**Responses to Comments**  
on the  
**Draft Environmental Analysis**

for the  
**Low Carbon Fuel Standard and  
Alternative Diesel Fuel  
Regulations**

**Released September 21, 2015**  
to be considered at the  
**September 24, 2015 Board Hearing**

**Figure 1a**  
**Results of Sierra Analysis of Statewide NOx Increases**  
**Due to Biodiesel Use under the Proposed ADF Regulation**

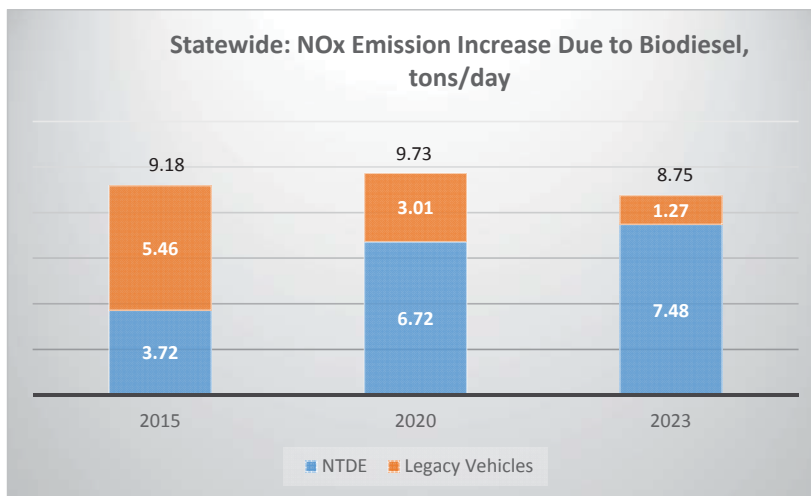
The results of the Sierra analysis are shown graphically in Figures 1a through c for the entire state as well as the South Coast and San Joaquin air basins, respectively. These figures also show the relative contributions of legacy vehicles and NTDEs to the total estimated for each area and year. As shown, the contributions of NTDEs to increased NOx emissions are substantial in 2015, and dominate the impacts in 2020 and 2023. Further data supporting these results are provided in Tables 6 through 8 at the end of this attachment.

**Figure 2**  
**The Impact of Biodiesel on NTDE NOx Emissions**

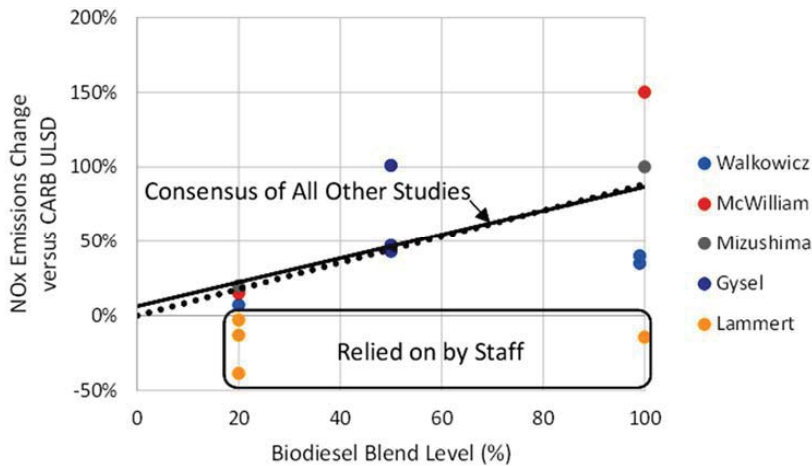
As indicated above, the Sierra analysis uses the results from an assessment of existing data regarding biodiesel impacts on NOx emissions from NTDEs performed by Rincon Ranch Consulting. The key findings of that analysis are shown in Figure 2 (reproduced with permission), which establishes that the available data for biodiesel impacts on NTDE NOx emissions follow a linear relationship just as they do for legacy vehicles.

Clearly, if CARB staff were truly taking a “precautionary approach” to the issue of biodiesel impacts on NTDE NOx emissions, they would also rely on the results of the analysis summarized in Figure 2.

**Figure 3a**  
**Results of Sierra Analysis of Statewide NOx Increases Due to Biodiesel Use in All NTDEs under the Proposed ADF Regulation**

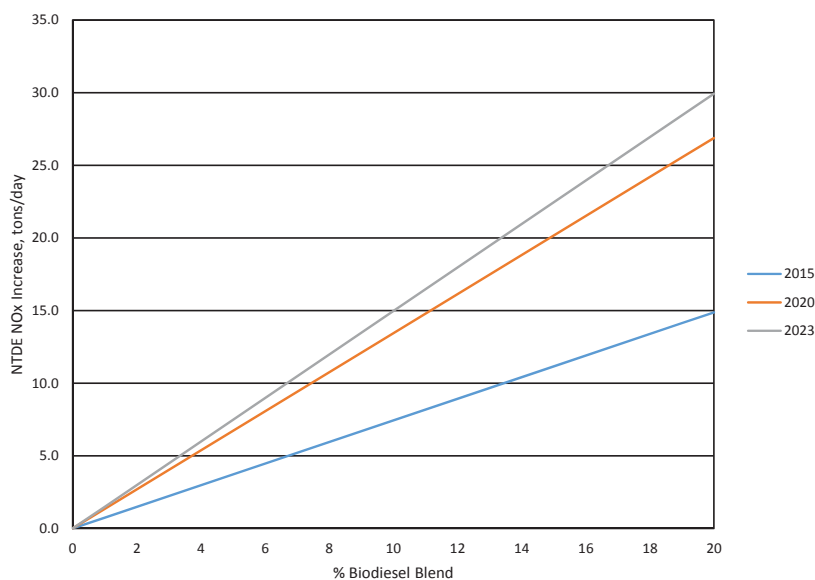
As shown, the potential NOx increases from extensive use of higher level biodiesel blends in NTDEs is quite large. Furthermore, although the results shown in Figures 3a through 3c are maximum potential impacts, they can again be simply scaled for other cases. For example, in order to estimate statewide NOx increases from B20 use in 50% rather than 100% of NTDEs, one would simply multiply the value of 30 tons per day by 0.5 (50/100) to arrive at a 15 ton per day increase. Finally, it should be noted that the values in Figures 3a through 3c reflect both on- and off-road NTDEs as described above for the Sierra analysis of B5 impacts.

**Figure 1**  
**Biodiesel Consumption in California as Reported by the California Energy Commission**

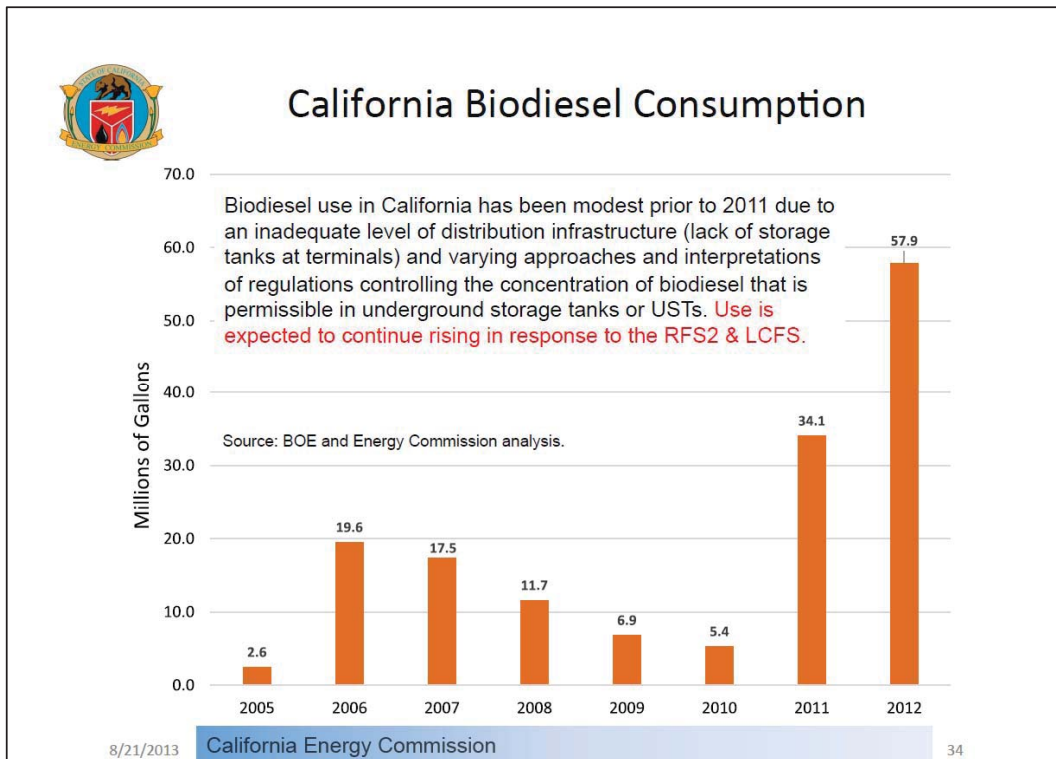
Although CARB does not disclose the amounts of biodiesel used in California prior to 72 million gallons estimated in 2014 in the ADF rulemaking documents (see ISOR Appendix B), data for 2005 to 2012 are available from the California Energy Commission.<sup>18</sup> These data are shown in Figure 1 below. As shown, biodiesel use in California increased dramatically in 2006 when CARB staff indicated that it would not regulate biodiesel, and then decreased until the LCFS

Figure 1-1  
Linear and Staff Threshold Models for Biodiesel NOx Impacts

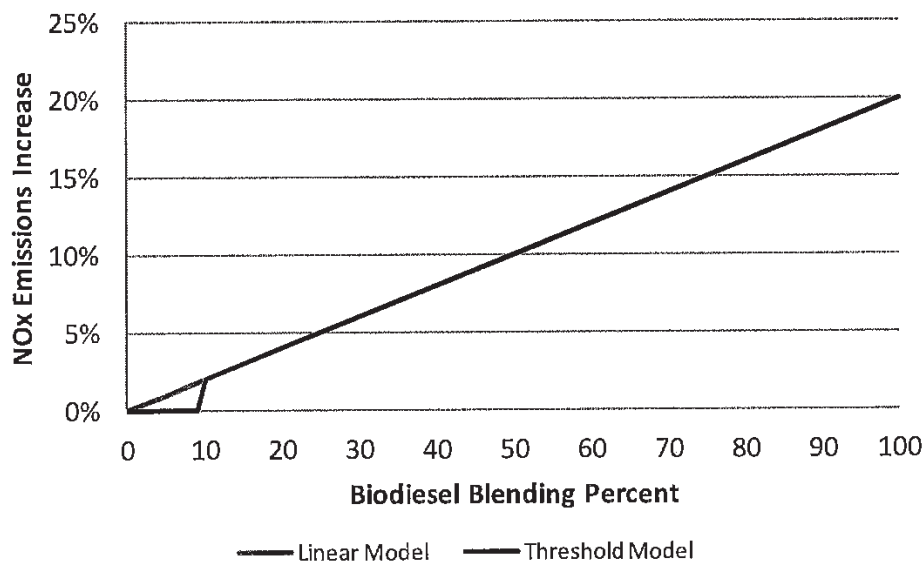
Existing research on the NOx emission effects of biodiesel has consistently been conducted under the hypothesis that the emission effect will be linearly proportional to the blending percent of neat biodiesel (B100) with the base diesel fuel. The Linear Model that has been accepted by researchers is shown as the blue line in Figure 1-1. The Staff position cited above is that biodiesel fuels do not increase NOx emissions until the fuel blend reaches 10% biodiesel. This so-called Staff Threshold Model departs from the Linear Model that underlies past and current biodiesel research by claiming that NOx emissions do not increase until the biodiesel content reaches 10 percent.

Figure 2-1  
NOx Emission Increases Observed in Biodiesel Research Cited in Staff ISOR

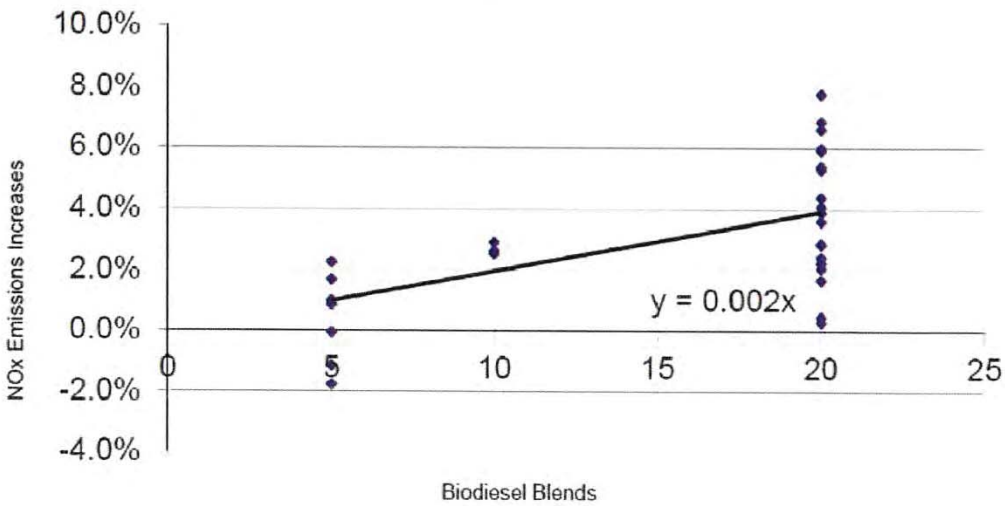
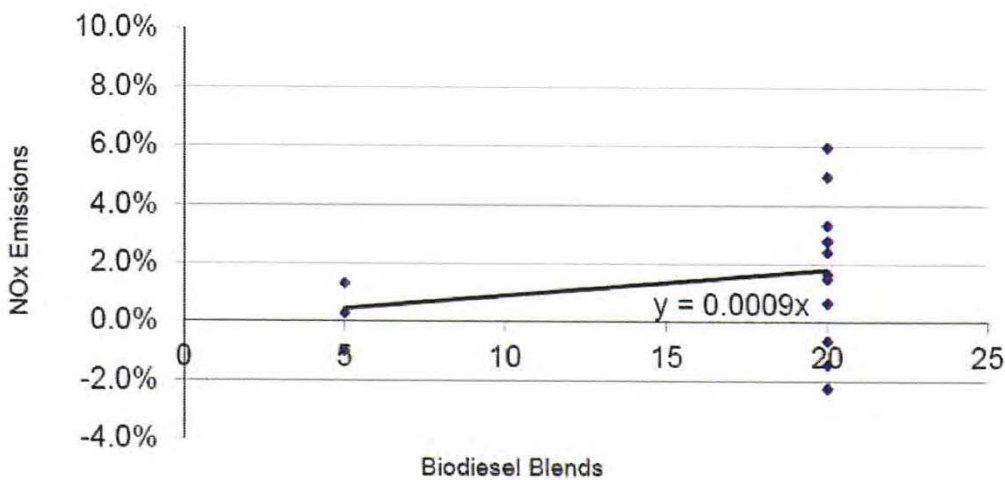
- The same result – reduced NOx emissions for some fuels and engines – has sometimes been observed in past research, as evidenced by the emissions data considered by CARB staff in ISOR Figure B.3 (reproduced in Figure 2.1 below). As shown, some animal-based B5 and B20 fuels reduced NOx emissions while others increased NOx emissions with the overall conclusion being that NOx emissions increase in direct proportion to biodiesel content of the blends and that there is no emissions threshold.
- Increasing cetane is known to generally reduce NOx emissions and has already been proposed by CARB as a mitigation strategy for increased NOx emissions from biodiesel<sup>14</sup>. The unusual cetane number response in the blending and the high cetane number of the B5-animal fuel may account for the results presented in the recently released study.

Figure 2-1 reproduces two exhibits from Appendix B that show increasing trends for NOx emissions with the biodiesel blending level. Based on the slopes of the trend lines,

Figure 2-2  
Impact of Biodiesel Blends on Percent NOx Change for the 5.9L ISB Engine Operation Over the FTP Cycle

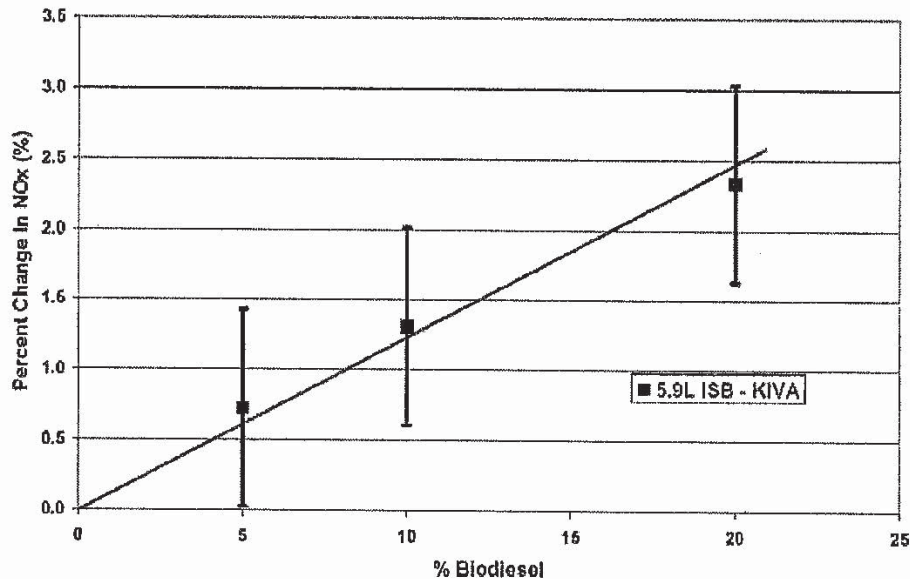
The study notes that two other studies “show that NOx emissions increase nearly linearly with the increase in the percentage of biodiesel added to diesel fuel.” Eckerle’s Figure 21 (reproduced below as Figure 2-2) indicates a NOx emissions increase at B5, which is the basis for the statement in the abstract that “Results also show that for biodiesel blends containing less than 20% biodiesel, the NOx impact over the FTP cycle is proportional to

Figure 3-1a  
 Durbin 2011 Assessment: 40 mph Cruise Cycle NOx Emissions Increases  
 for Soy-Biodiesel Blends (2006 Cummins Engine)

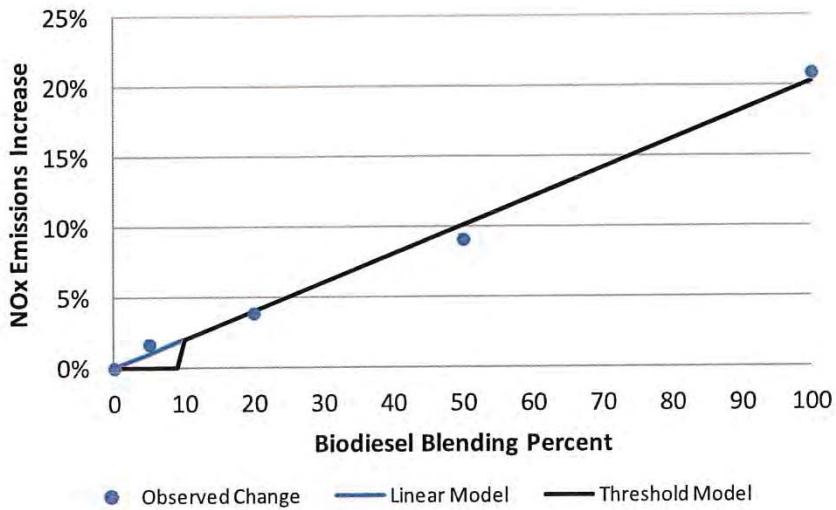
In Figure 3-1a, the linear model is an Excel trendline for the computed percent changes. While the data violate a key assumption for the proper use of regression analysis, this approach is the only way to establish a trendline given the form in which Durbin 2011 tabulates the data and presents the results of its testing.

Note that the slope of the trendline (Figure 3-1a) is greater than the slope of the regression line (Figure 3-1b). In the latter figure, the B100 data point stands above the regression line, which passes below it. The regression line (but not the trendline) is fit in

Figure 3-1b  
 Re-assessment of 40 mph Cruise Cycle NOx Emissions Increases  
 for Soy-Biodiesel Blends (2006 Cummins Engine)

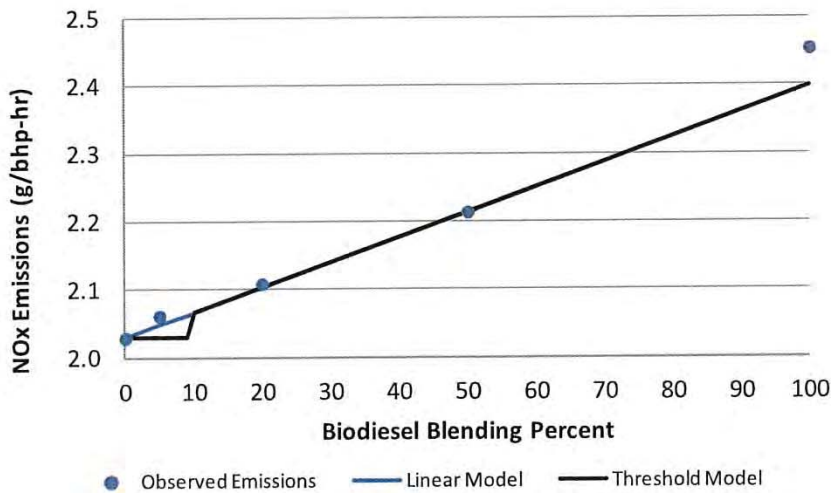
Figure 3-1b plots the actual measured emission values in g/bhp-hr terms in contrast to the same two analytical models. Here, the linear model line is determined through a proper use of regression analysis, in which each emission average in g/bhp-hr terms is weighted inversely by the square of its standard error, using the data for ULSD, B20, B50 and B100 (i.e., excluding the B5 data point). In the case of this engine and biodiesel fuel, both forms of assessment show generally the same trend for NOx emissions as a function of blending percent. Although the NOx emission increases for B5 may fail the t-test for significance, emissions are increased at B5 and the B5 data point is fully consistent with the Linear Model. The Threshold model is clearly a less-satisfactory representation of the test data.

Figure 3-2a  
 Durbin 2011 Assessment: FTP NOx Emissions Increases for Animal-based Biodiesel Blends (2006 Cummins Engine)

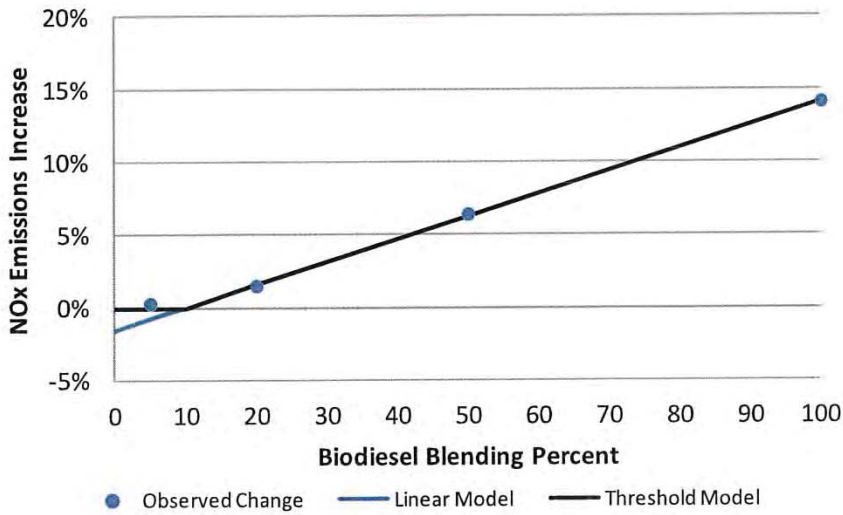
Figures 3-2a and 3-2b display the trend of NOx emissions with blending percent for the animal-based biodiesel on the FTP test cycle as reported by Durbin 2011 and as re-assessed in this report using regression analysis, respectively. As Figure 3-2a shows, the NOx percent change values reported by Durbin 2011 appear to follow the Staff Threshold model in that NOx emissions are not materially increased at B5, but are increased significantly at B20 and above. As a result, the blue trendline in the figure (fit from the B20, B50 and B100 data points) has a negative intercept.

Because the ULSD data point is subject to more uncertainty and appears to be biased high compared to the regression line, the NOx percent changes computed by Durbin 2011 are themselves biased. The trendline result in Figure 3-2a that appeared to be supportive of the Staff Threshold model now appears to be the result of biases in the ULSD and B5 emission averages.

Figure 3-2b  
 Re-assessment of FTP NOx Emissions Increases for Animal-based Biodiesel Blends (2006 Cummins Engine)

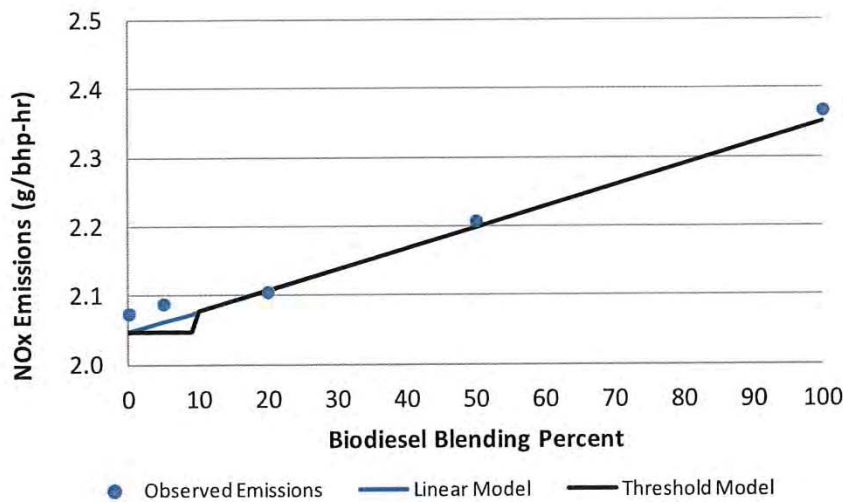
Figure 3-2b paints a very different picture from the data. Here, the ULSD and B5 data points stand above the weighted regression line (blue) developed from the data for ULSD, B20, B50 and B100. In the data used to fit the regression line, the ULSD data point has the largest uncertainty ( $\pm 0.013$  g/bhp-hr) while the other three data points (B20, B50, and B100) have uncertainties of  $\pm 0.002$  g/bhp-hr (one case) and  $\pm 0.001$  g/bhp-hr (two cases). Considering all of the data, the B5 data point has the second highest uncertainty ( $\pm 0.007$  g/bhp-hr). The regression line closely follows a linear model with a high  $R^2$  (0.981) considering the weighted errors, while the ULSD and B5 points lie above it.

Figure 3-4  
 Durbin 2011 Assessment: ISO 8178 Cycle NOx Emissions Increases for Soy-based Biodiesel Blends (1998 Kubota Engine, Test Series 1 and 2 Combined)

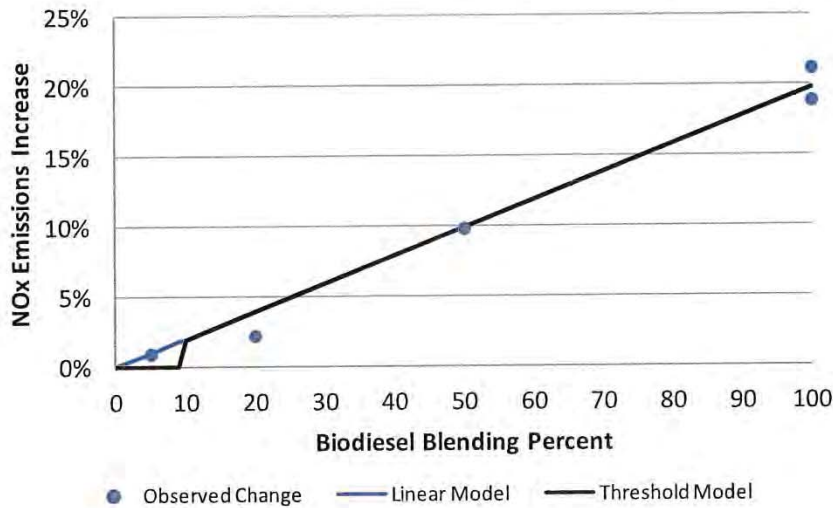
Figure 3-4 displays the trend of NOx emissions with blending percent for the first and second test series combined. As the figure shows, the available data points scatter around the trendline determined from the emission change percentages (not from regression analysis). The B20 data point falls below the trend line while the two B100 data points bracket the trend line. It is not possible to explain the divergence of the B20 data point

**Figure 1. Cetane Blending Behavior of Animal Blends (Solid Lines) Compared to B100 Feedstocks (Dotted Lines)**

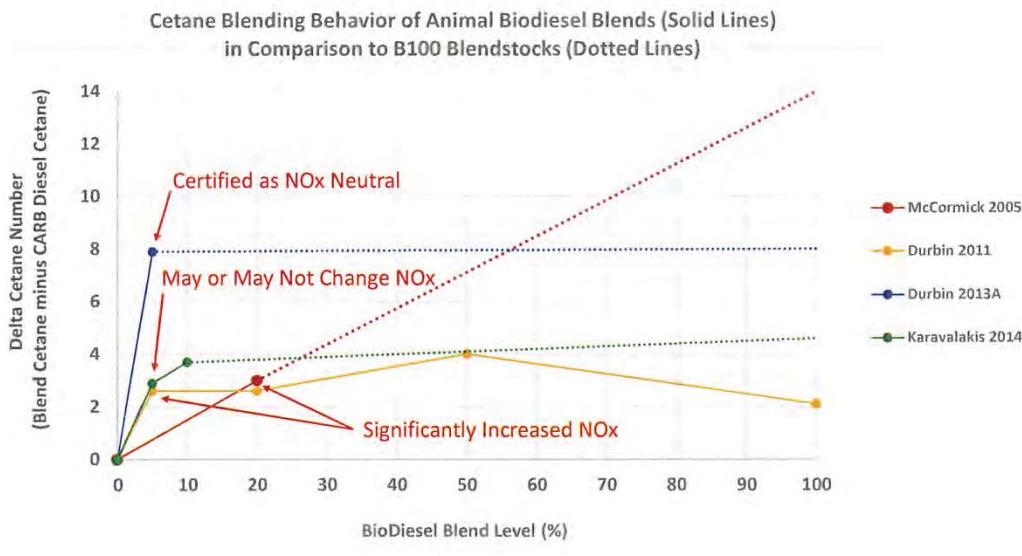
The effect of feedstock blending on the CN of the resulting animal blend is the reason for the apparently discordant results among the studies. Figure 1 plots the four series of animal blends in the literature with the blend level on the horizontal axis and the change in blend CN (relative to CARB diesel) on the vertical axis. CN blended linearly to B20 for the McCormick feedstock, which showed a much smaller CN benefit than the feedstocks used by UCR – only three numbers at B20 (0.6 numbers at B5). In contrast, all three UCR animal blends achieve a large CN boost at low blending levels in which most or all of the CN benefit of the feedstock is achieved at B5.

**Figure 2. There Are No Detectable Differences Among Feedstock Types Once NOx Emissions Are Adjusted to Constant CN**

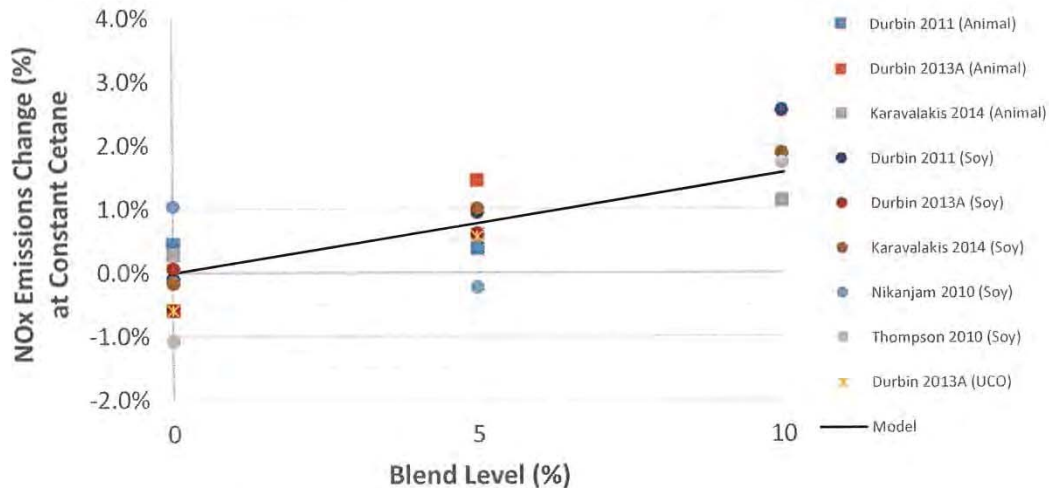
To demonstrate these conclusions, Figure 2 presents NOx emissions as a function of blend level for all fuels used to estimate the model once NOx emissions are adjusted for the CN change observed for each blend (animal blends are plotted as squares, soy blends as circles, and the non-soy vegetable blends as asterisks). For example, if an animal blend increased CN, then its NOx impact is increased as we return it to the base fuel CN. If a soy blend decreases CN, then its NOx impact is decreased as we return it to the base fuel CN. Once adjusted, percent changes in emissions are calculated. As seen in the figure, there is no discernable difference among feedstock types once CN changes are taken into account. Animal and soy blends scatter on both sides of the regression line, indicating that they obey the same blend level model.

**Figure 1. Cetane Blending Behavior of Animal Blends (Solid Lines) Compared to B100 Feedstocks (Dotted Lines)**

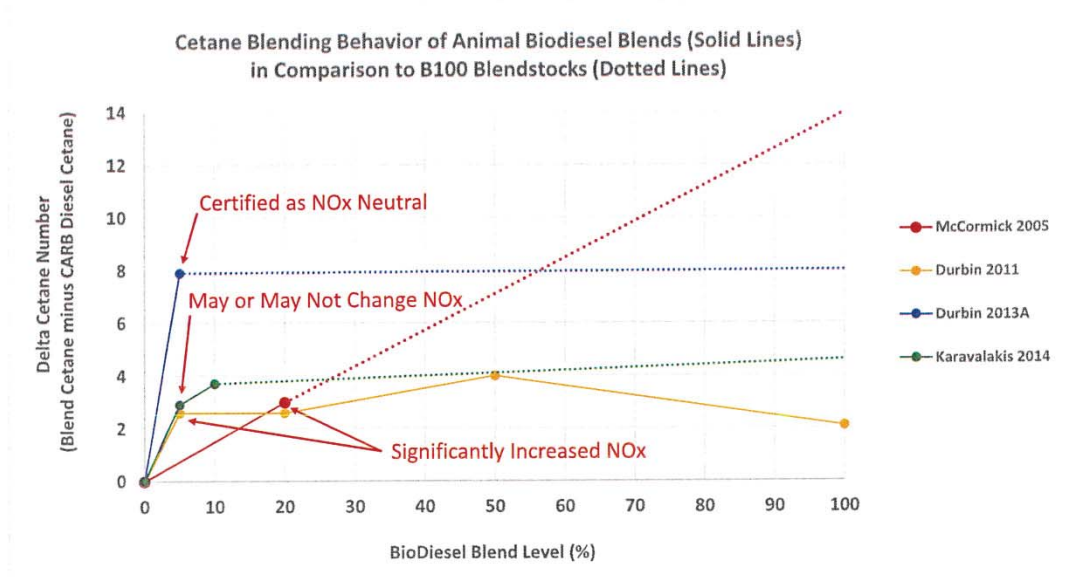
The effect of feedstock blending on the CN of the resulting animal blend is the reason for the apparently discordant results among the studies. Figure 1 plots the four series of animal blends used in the studies, with blend level on the horizontal axis and the change in blend CN (relative to CARB diesel) on the vertical axis. CN blended linearly to B20 for the McCormick feedstock, which showed a much smaller CN benefit than the feedstocks used by UCR—only three numbers at B20 (0.6 numbers at B5). In contrast, all three UCR animal blends achieve a large CN boost at low blending levels in which most or all of the CN benefit of the feedstock is achieved at B5.

Staff's use of the terms low saturation (for soy) and high saturation (for animal) to classify biodiesel is useful to differentiate between feedstocks that will tend to decrease CN and those that will tend to increase it. However, it is not a sufficient step in that the CN change at each blend level is the determinative factor for NOx emissions, not the CN of the feedstock itself. Soy feedstocks appear to blend linearly with respect to cetane; however, animal feedstocks often lead to a highly non-linear CN response, as shown in Figure 1.
